WIPLINE FLOATS • SKIS • MODIFICATIONS • AIRCRAFT SALES
AVIONICS • INTERIOR • MAINTENANCE • PAINT REFINISHING

SERVICE LETTER 243

Hydraulic Pump Pressure Settings for 2100A, 2350A, 3000A, and 3450A Floats

Figure 1 – Hydraulic Pump

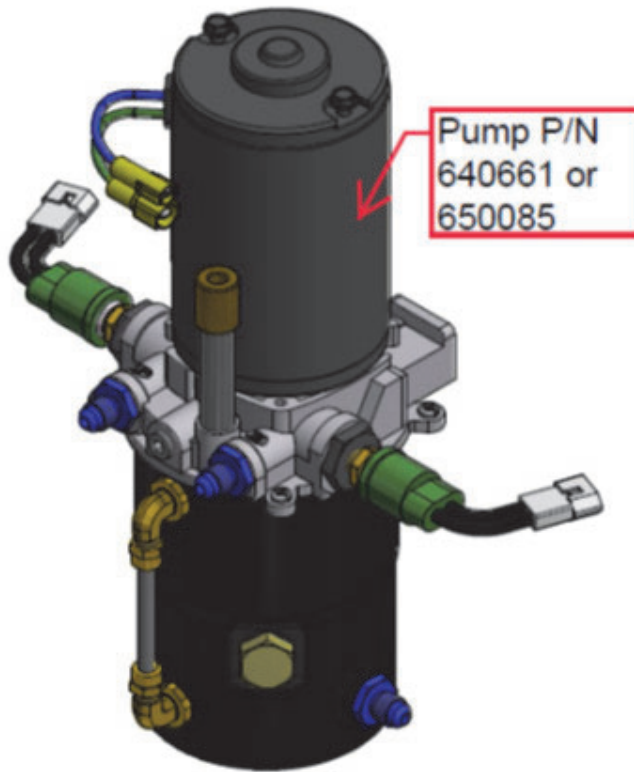
2. See Figure 1 below. On the hydraulic pump (power pack) assembly, check for the part number of the pump.
 - A. If the pump unit is P/N 640661, no further action is needed. Close access and continue to Aircraft Closing & Return to Service section.

- B. If the pump unit is P/N 650085, pressure and thermal relief valves adjustments will be needed. This can be accomplished by either:
 - a) Remove the entire pump power pack assembly using the installation drawings in Table 1 as a guide. Contact Wipaire customer service to ship the power pack back to Wipaire for adjustments

Figure 2 – Up / Dn Pressure and Thermal Relief Valve Location

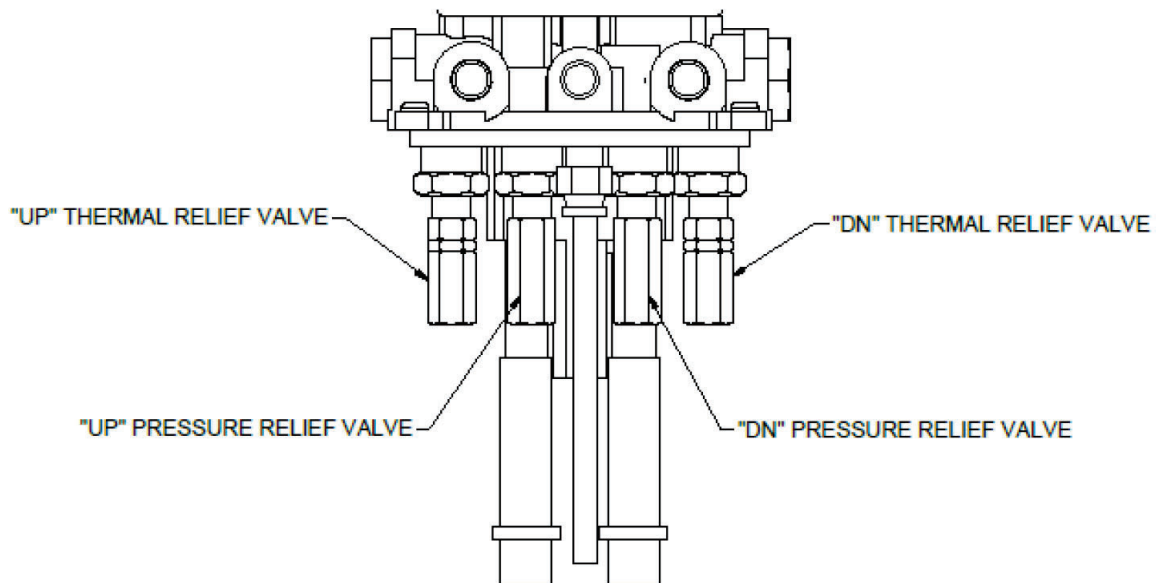
- b) Adjust the pressure and thermal relief valves (Reference Figure 2):
 1. Disable the pressure switches by jumping the switch ground connections.
 2. Connect power and ground to motor from a hydraulic test bench.

3. Connect hydraulic lines from a hydraulic test bench to "UP" and "DN" ports.
 4. Set the "UP" pressure relief valve to ~2000 psi by loosening the jamb nut and turning the pressure relief valve clockwise all the way in. Tighten jamb nut when pressure is set

5. Loosen jamb nut on "UP" thermal relief valve.
 6. Activate power to run the pump in the "UP" position. Rotate "UP" thermal relief valve counterclockwise until 1000 +/- 50 psi is achieved. Deactivate power and tighten jamb nut after setting pressure. Run pump again to verify thermal relief pressure is set at 1000 +/- 50 psi.

7. Repeat the same steps to set "DN" thermal relief valve to 1000 +/- 50 psi.
 8. After thermal relief valves are set, loosen jamb nut on "UP" pressure relief valve.

9. Activate power to run the pump in the "UP" position. Rotate "UP" pressure relief valve counterclockwise until 800 +/- 50 psi is achieved. Deactivate power and tighten jamb nut after setting pressure. Run pump again to verify pressure relief valve is set at 800 +/- 50 psi.

10. Repeat the same steps to set "DN" pressure relief valve to 800 +/- 50 psi.
11. Locally fabricate a placard similar to Figure 3, or contact Wipaire Customer Service to purchase placard p/n 1011996. Place the placard over the top of the current placard on the pump once pressure has been corrected.
